FINAL DRAFT MINUTES

June 16, 2022 Standards Committee Meeting

RE: Minutes from the June 16, 2022 Standards Committee Meeting

E 801-TCCO-08 TUBULAR MARKER DELINEATION (PROPOSED DRAFT)

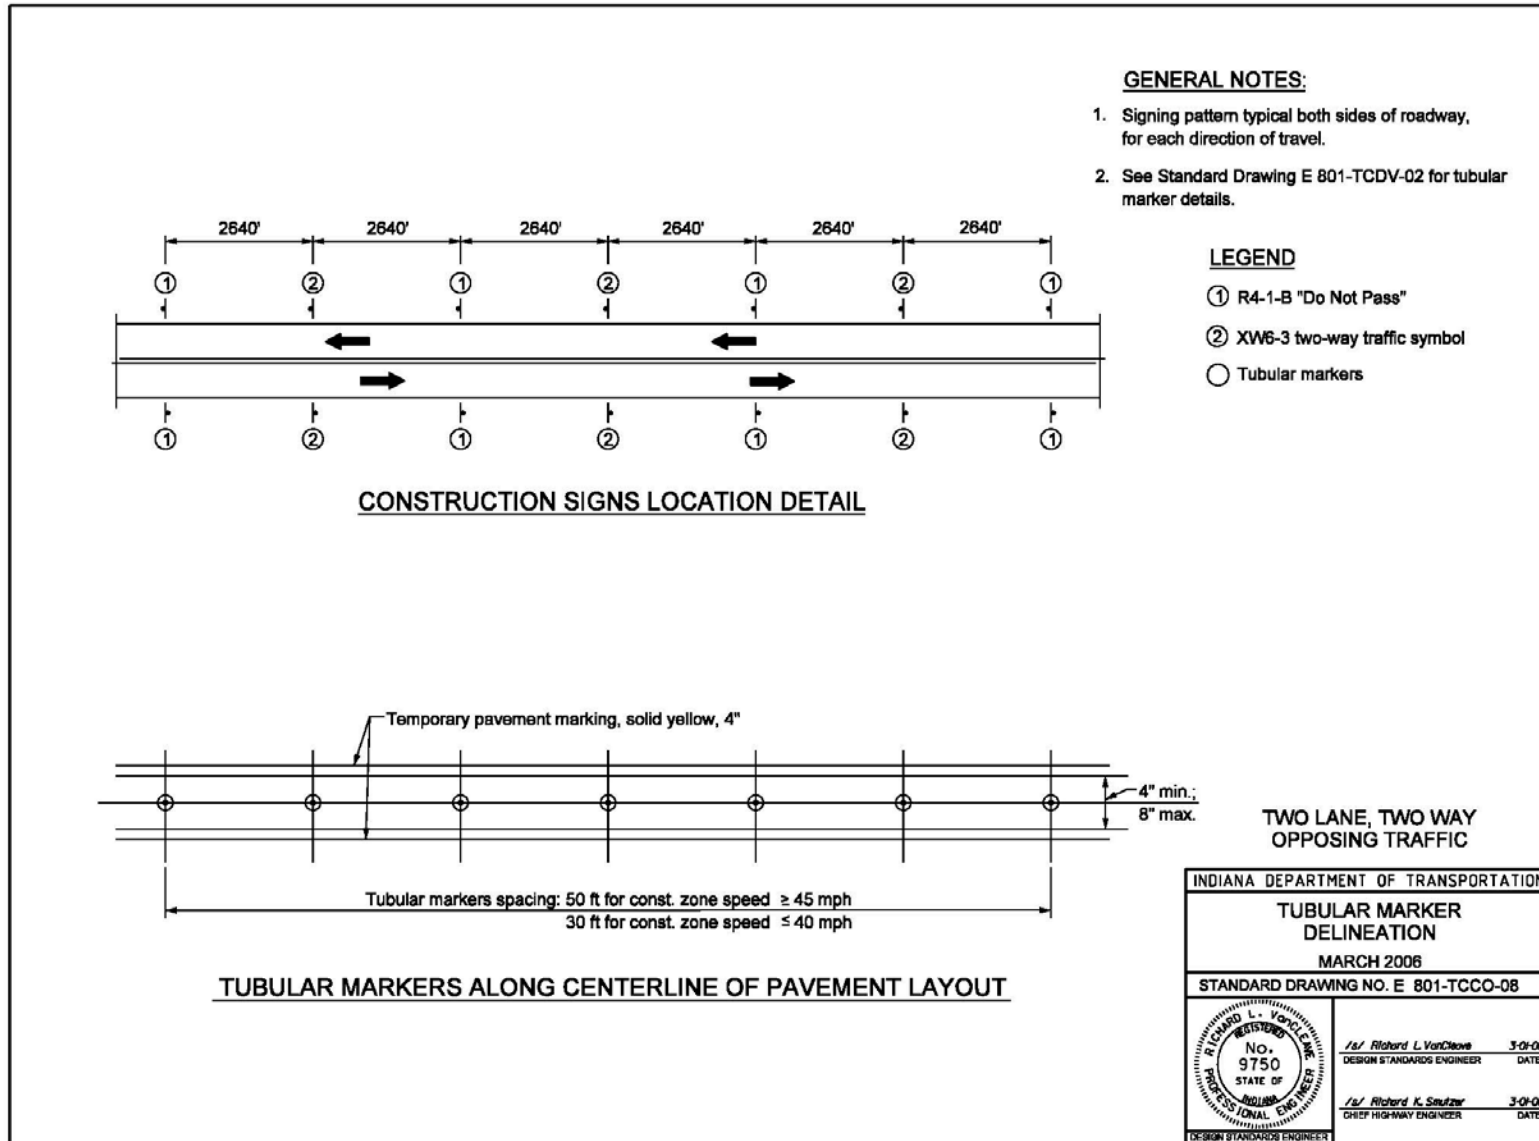
Move to 801-TCCO-08

E 801-TCCO-09 TUBULAR MARKER DELINEATION AT INTERSECTION (PROPOSED DRAFT)

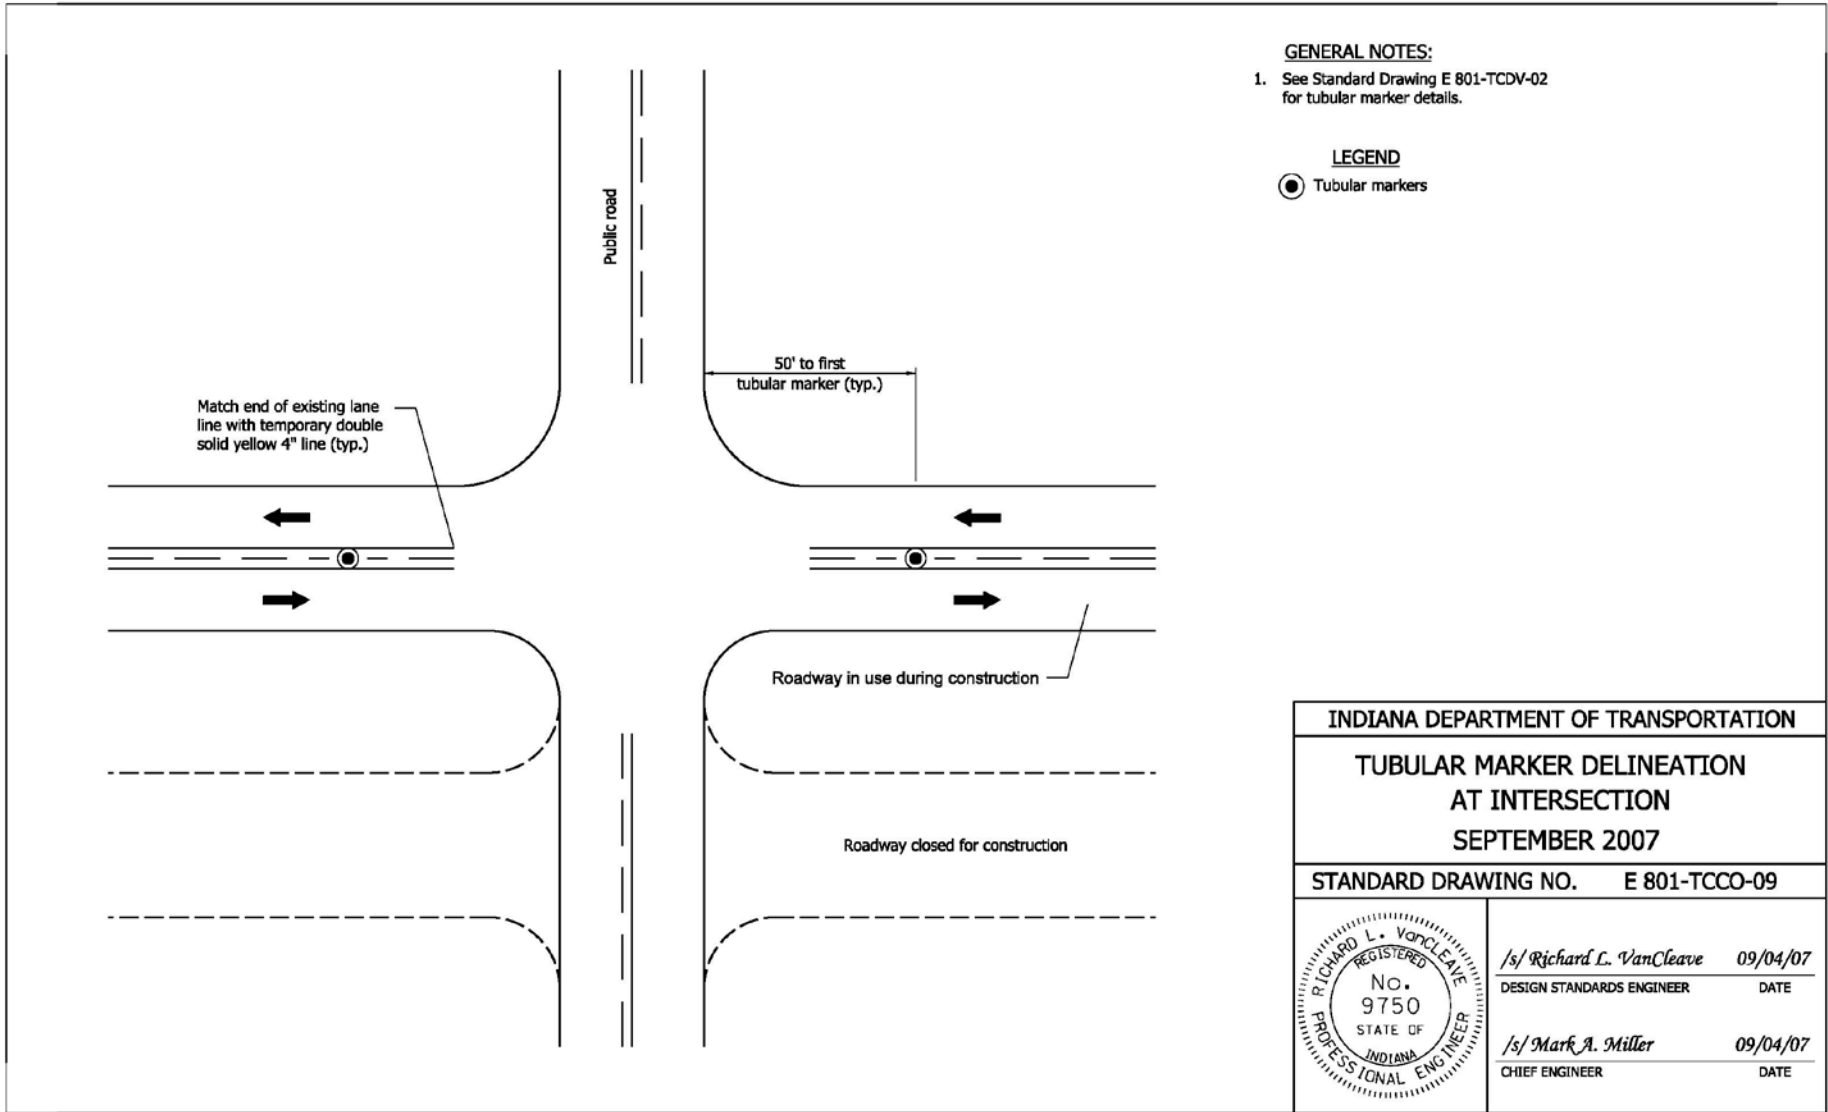
Move to 801-TCCO-09
